Re: May 7, 2001 Conference Call

May 24, 2001
Project No. 5427F-02

Nuclear Regulatory Commission Teleconference
Dated May 7, 2001
Kaiser Aluminum & Chemical Corporation
Tulsa, Oklahoma

FIGURE 2
AFFECTED AND UNAFFECTED AREAS
ADJACENT LAND AREA REMEDIATION
KAISER ALUMINUM
TULSA, OKLAHOMA

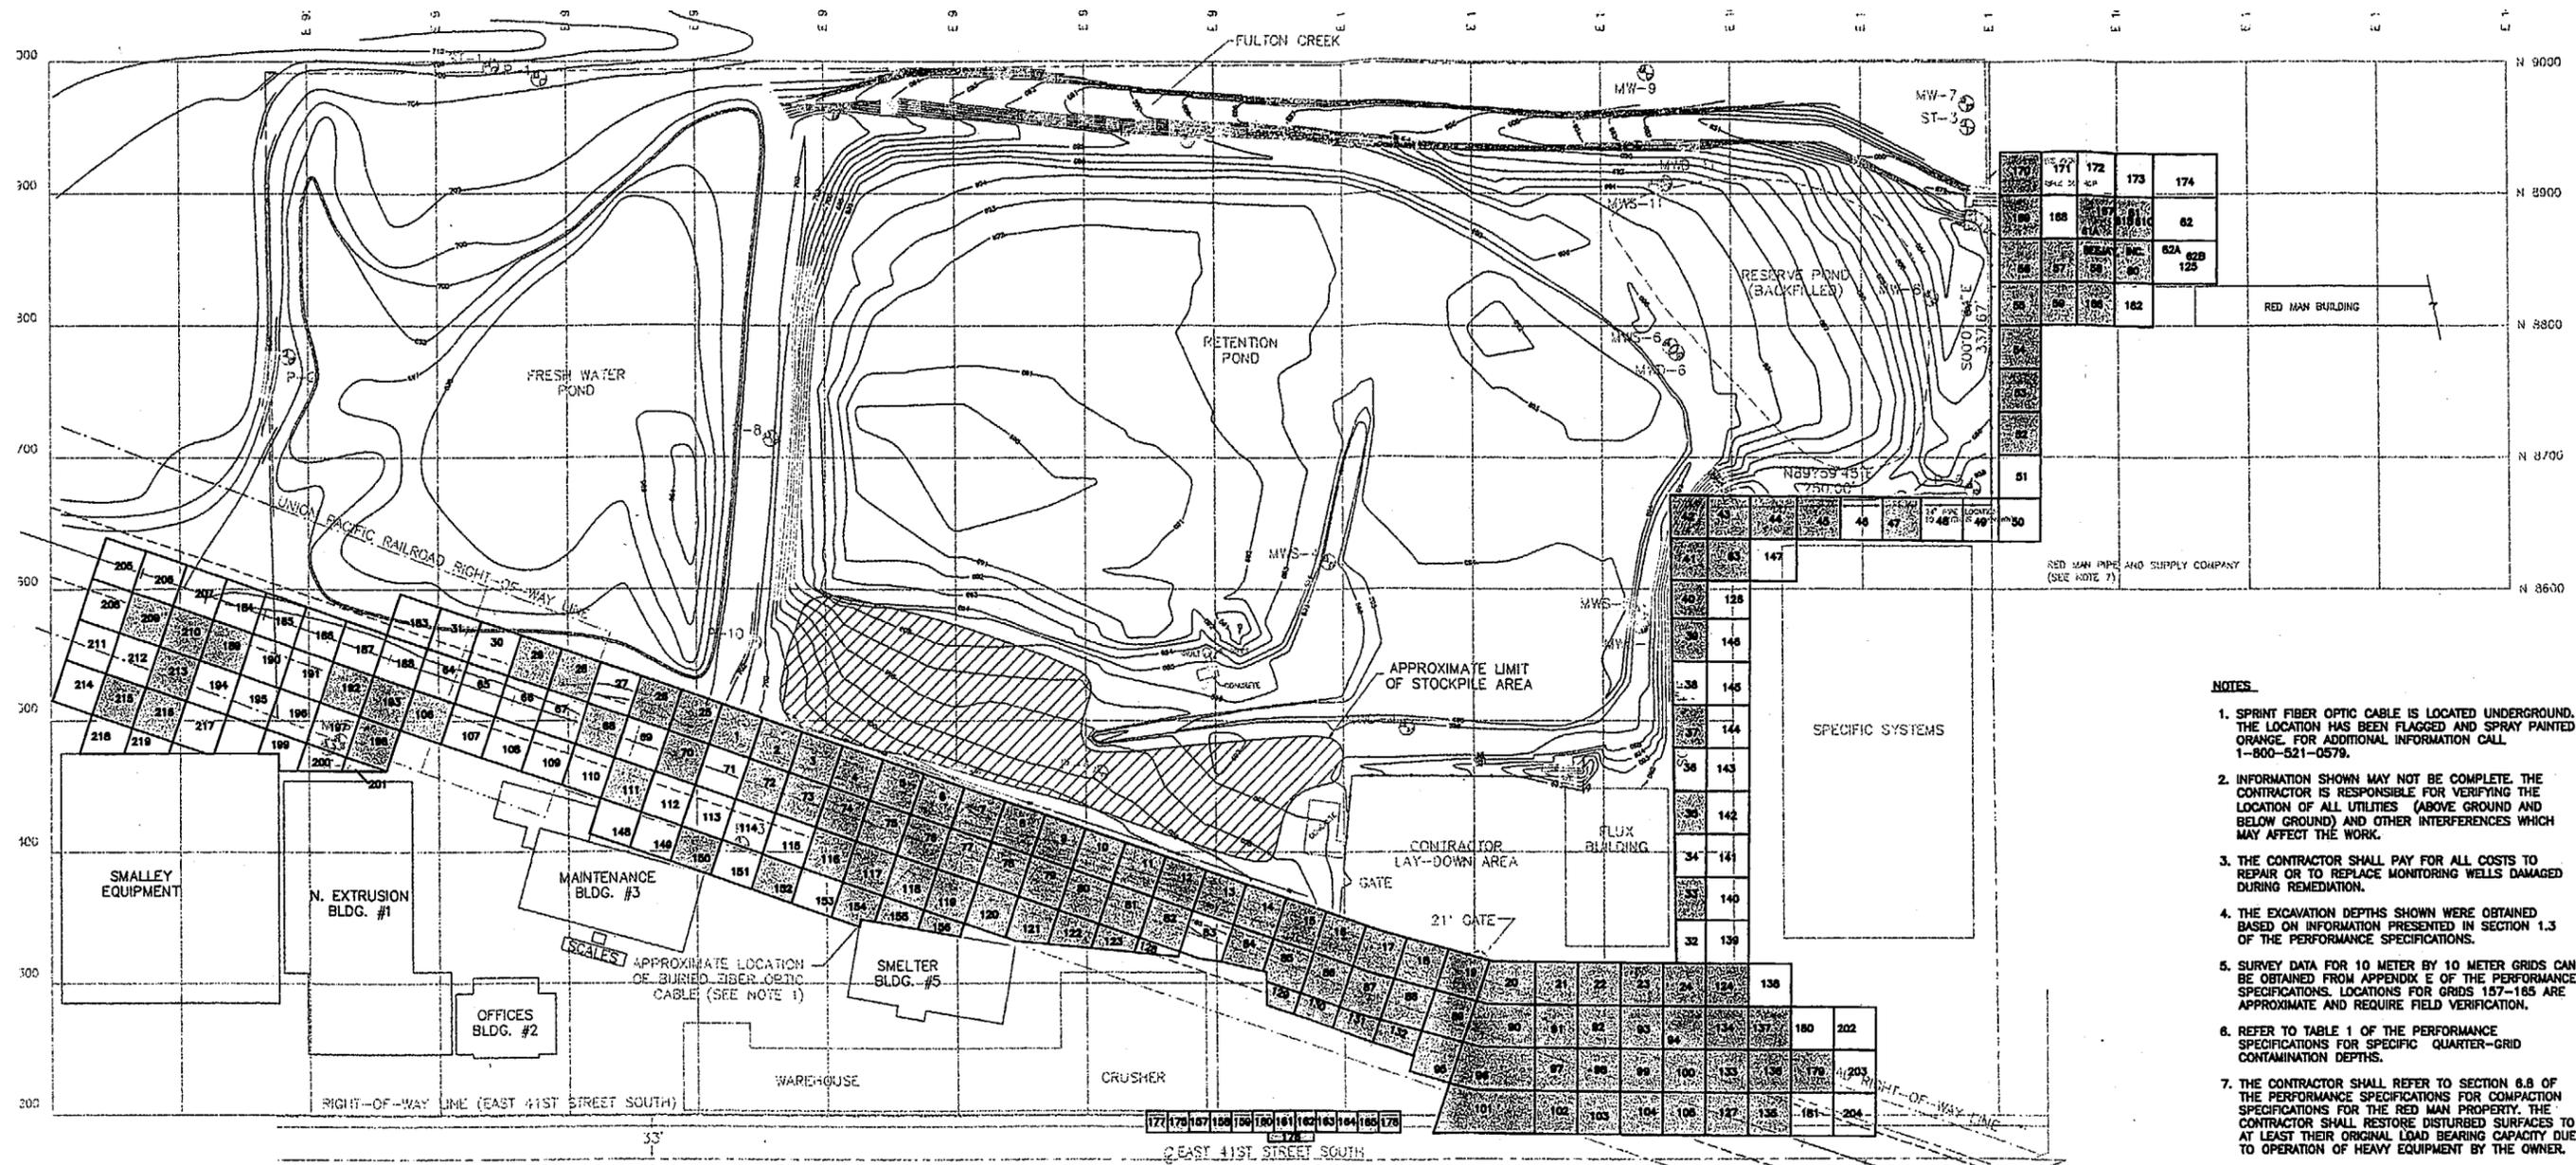
- DEV01 – An updated figure of the adjacent land area with all of the characterization grids delineated as affected or unaffected will be forwarded to the NRC. In addition, a matching table of Characterization Grids, their status (affected or unaffected), the basis of the status, and any additional comments are attached.
